DART SERVICE INSTRUCTION

TO AMEND INSTALLATION INSTRUCTIONS IIN-D350-636 REV. J AND INSTRUCTIONS FOR CONTINUED AIRWORTHINESS ICA-D350-636 REV. 3

REF FAA STC: SR00646SE
REF TCCA STC: SH99-7
REF EASA STC: EASA.10033942
REF BRAZIL STC: 2009S05-01

FIGURE 1: Blade Fitting Assembly Rework

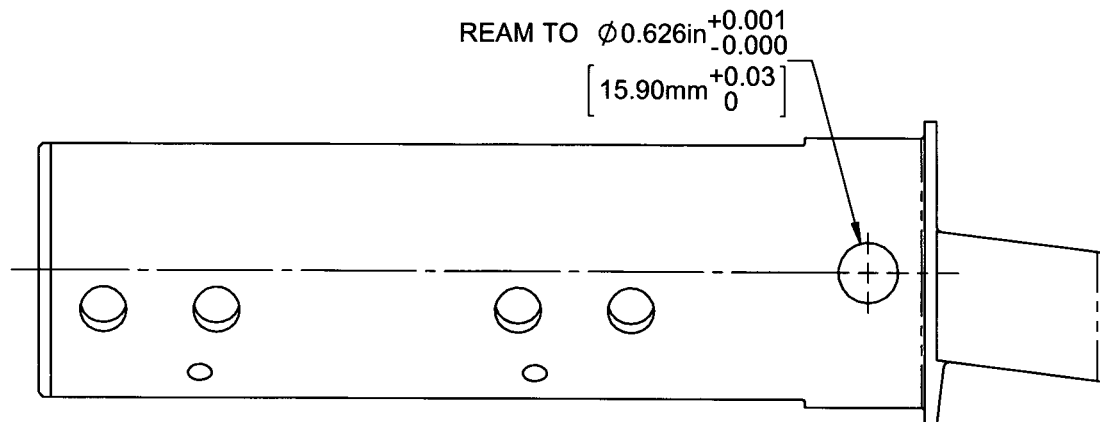
It has come to DART's attention that the fit between the 12 mm Bolt required to fasten the aft most float mounting bracket of the Aerazur Floatation System to the existing provisions in the DART Skid tubes may be too loose. In such cases, it is acceptable for the installer or maintainer to proceed with the following steps:

- 2.1 Locate $\varnothing 0.508$ in (12.9mm) hole in the D3488-041/-042 Blade Fittings and enlarge to $\varnothing 0.610$ in (15.5mm), then ream to $\varnothing 0.626$ in $+0.001$ in/ -0.000 in (15.5mm $+0.15/-0$) as shown in Figure 1 of this Service Instruction.
- 2.2 Deburr and touch up finish in accordance with Chapter 5 of ICA-D350-636.

FIGURE 2: Bushing Detail

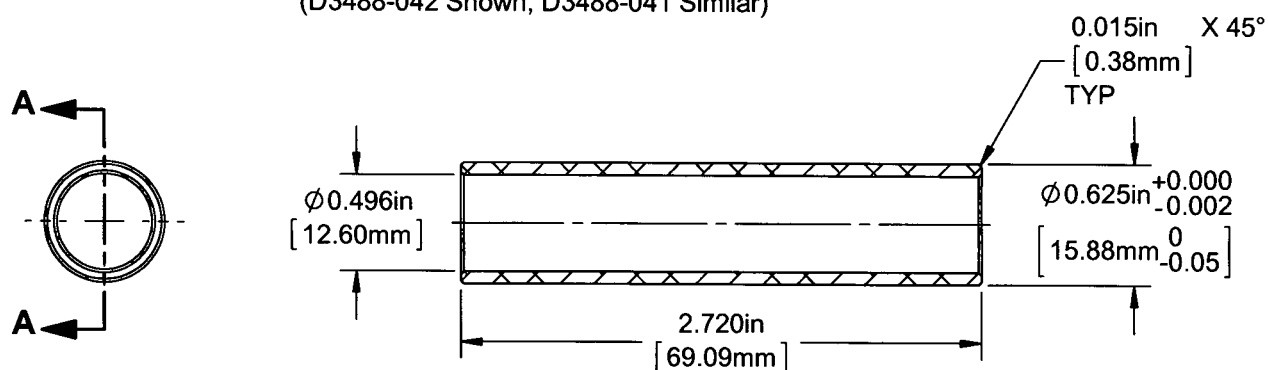
- 3.1 Fabricate qty(1) bushing for each Blade Fitting Assembly in accordance with Figure 2 of this Service Instruction and to the following material specifications: 7075-T73 (or 7075-T7351/T73510/T73511) round bar per AMS-QQ-A-200/11 or AMS-QQ-A-225/9.
- 3.2 Ensure the bushings can be installed into the holes that have been reworked on the D3488-041/-042 Blade Fitting Assemblies: the edges of the bushing should not protrude from the surface of the D3488-041/-042 Blade Fitting Assemblies. Adjust length of bushings to clear as required.

FIGURE 3: Assembly Detail

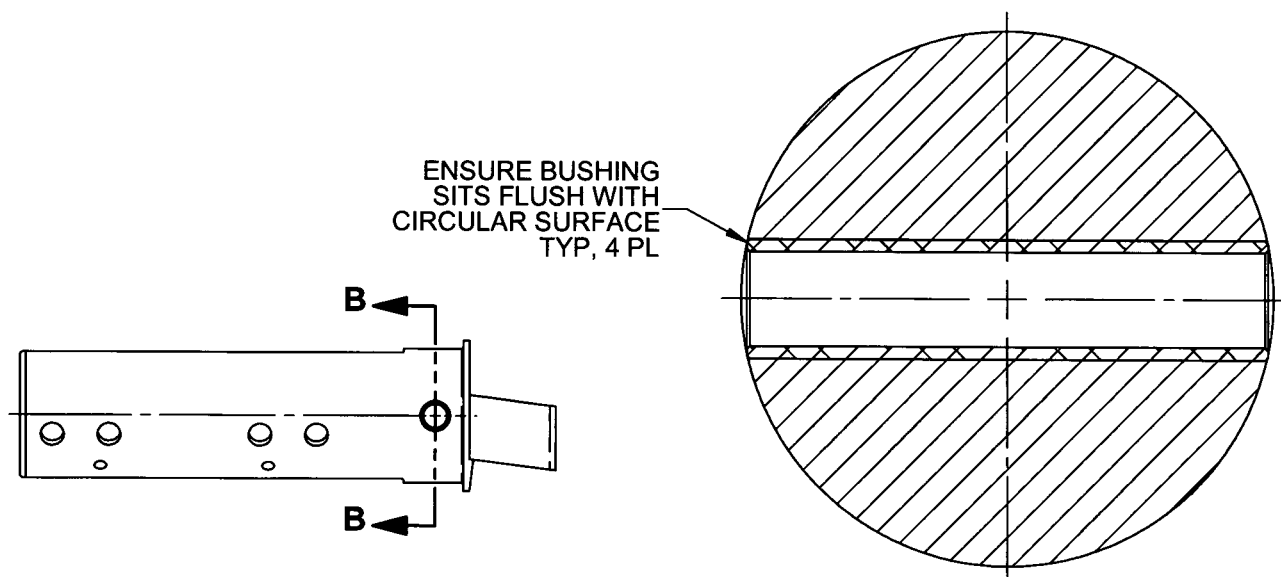
- 4.1 Bond bushings to the D3488-041/-042 Blade Fitting Assemblies using Proseal 890 Class B or AMS-S-8802 Class B sealant or 3M DP460 Scotch-Weld Epoxy Adhesive in accordance with the manufacturer's instructions. Ensure the inside of the bushings are free from sealant or adhesive. Refer to Figure 3 of this Service Instruction.
- 4.2 Allow sealant or adhesive to cure in accordance with the manufacturer's instructions.
- 4.3 Install the reworked D3488-041/-042 Blade Fitting Assemblies in accordance with Chapter 3.5 of IIN-D350-636 or Chapter 32.4 of ICA-D350-636.
